Historic Landmarks Committee
McMinnville Civic Hall, 200 NE 2nd Street
September 26, 2019 3:00 PM

A. DDR 1-19: 1025 NE 1st Street -
Review of Built Example of Exterior Materials
Review of Proposed Exterior Building Colors

DATE: September 26, 2019
TO: Historic Landmark Committee Members
FROM: Chuck Darnell, Senior Planner
SUBJECT: DDR 4-19 (Downtown Design Review for New Construction including Waiver Requests) – 118 NE 3rd Street

Building Foundation

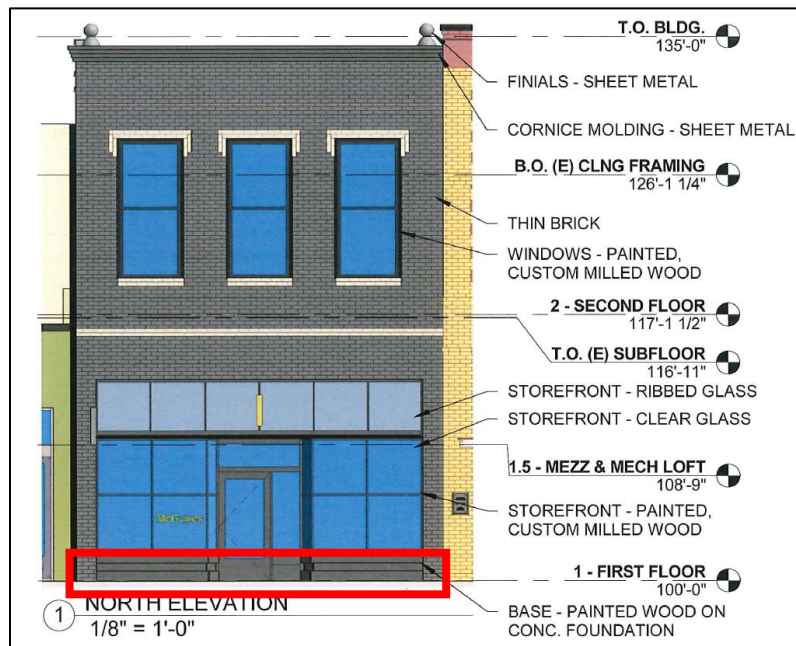
The application narrative describes the foundation or base of the building similarly to the proposed bulkhead, which is provided primarily in areas that have windows along the ground floor façade. However, a true foundation or base is not specifically identified in the elevations and renderings. A more typical type of foundation that has been included on more recent new construction within the Downtown Design area is a continuous concrete foundation immediately above the sidewalk and below the beginning of the primary exterior building material. Examples of this continuous concrete foundation are provided below:

The Historic Landmarks Committee should determine whether the larger foundation proposed by the applicant is acceptable, or whether a smaller foundation similar to the type identified above should be incorporated into the building design. If it is determined that it should be included, staff would suggest that the Historic Landmarks Committee develop a condition of approval to require the smaller concrete foundation to be included in the construction plans submitted for building permit review.

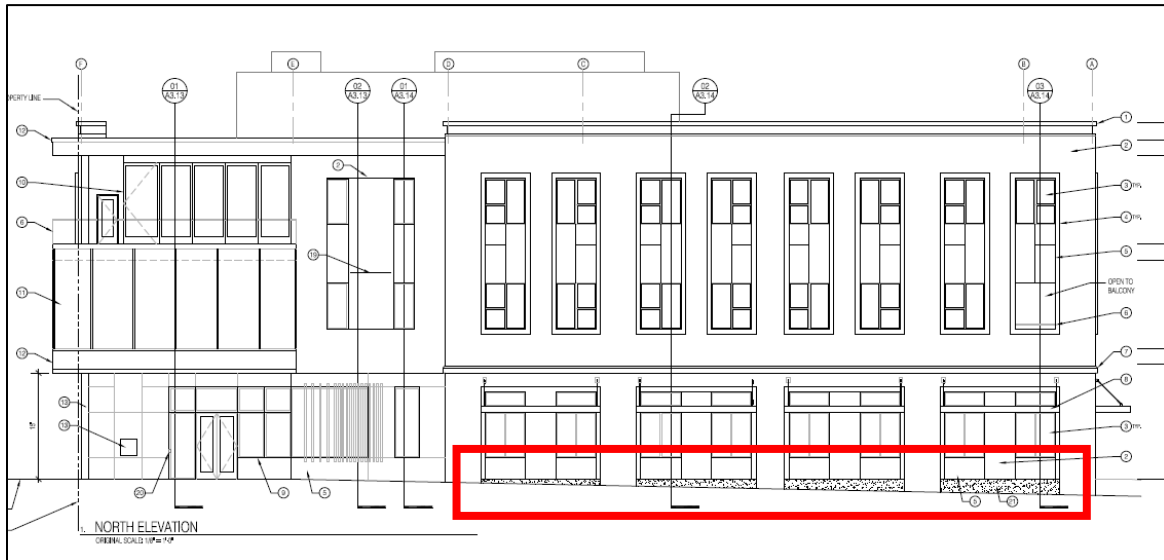
One portion of the façade that is identified differently in the elevation drawings and the renderings is the exposed foundation beneath the windows on the western portion of the 3rd Street façade. This portion of the façade is identified in the elevation on Exhibit C9 as “Exposed Foundation Wall, Skim Coat”, but shows up in the renderings as a consistent material beneath the windows to the sidewalk. The applicant has verified that the elevation drawing is correct, and that the exposed foundation wall would be visible in these areas of the façade, and finished with the cement plaster that is similar to smooth stucco. In order to maintain a cohesive finish beneath the windows and for consistency in this area that is described as the bulkhead in other areas of the application narrative, a condition of approval is suggested to be included to require that the skim coated exposed foundation wall be painted a tan color to match the stone panels that will be above. Alternatively, the condition of approval is suggested to also allow for the applicant to install the stone panel over the foundation wall from the bottom of the window all the way to the sidewalk.

This discrepancy between the elevation drawings and the renderings can be seen below:

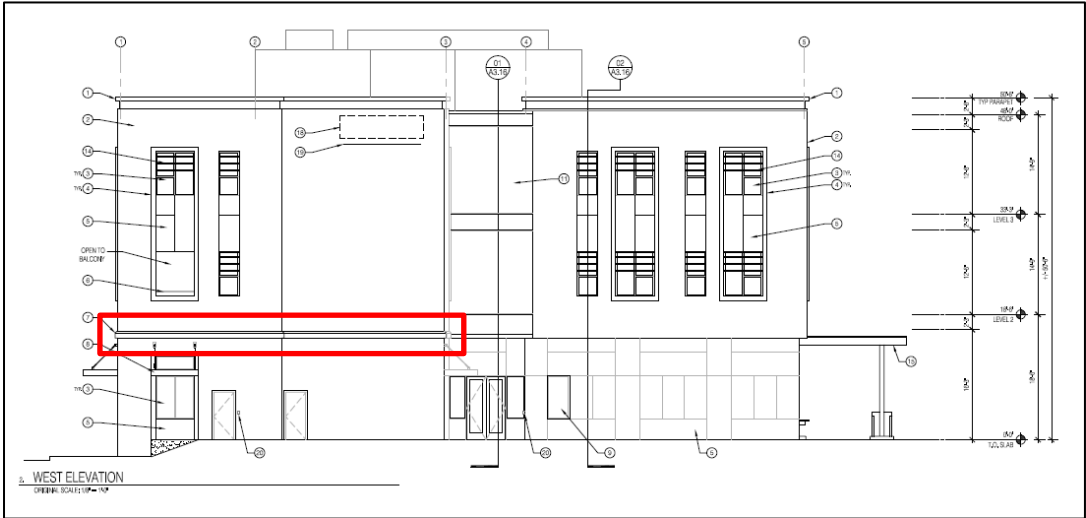
FINDING: SATISFIED WITH CONDITION #4. The City concurs with the applicant’s findings. However, the brick soldier course described by the applicant is not identified in the building elevations or the building renderings. Therefore, a condition of approval is included to require that the construction plans submitted for building permit review include a detail of the proposed brick soldier course along all areas of the façade that do not include a precast concrete belt course. The soldier course shall be at the same height as the precast concrete belt course.

The precast concrete belt course is proposed in the following locations on the façade:

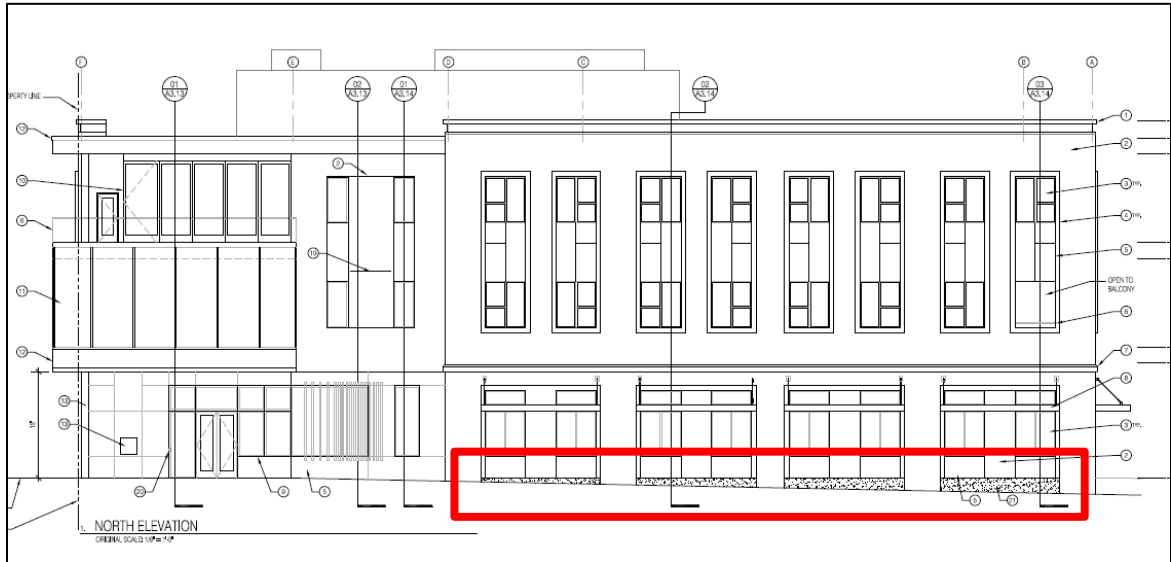
One portion of the façade that is identified differently in the elevation drawings and the renderings is the exposed foundation beneath the windows on the western portion of the 3rd Street façade. This portion of the façade is identified in the elevation on Exhibit C9 as “Exposed Foundation Wall, Skim Coat”, but shows up in the renderings as a consistent material beneath the windows to the sidewalk. The applicant has verified that the elevation drawing is correct, and that the exposed foundation wall would be visible in these areas of the façade, and finished with the cement plaster that is similar to smooth stucco. In order to maintain a cohesive finish beneath the windows and for consistency in this area that is

described as the bulkhead in other areas of the application narrative, a condition of approval is included to require that the skim coated exposed foundation wall be painted a tan color to match the stone panels that will be installed above the exposed foundation wall and beneath the windows. Alternatively, the applicant may install the stone panel material over the foundation wall to encompass the entire area from the bottom of the window to the sidewalk.

This discrepancy between the elevation drawings and the renderings can be seen below:
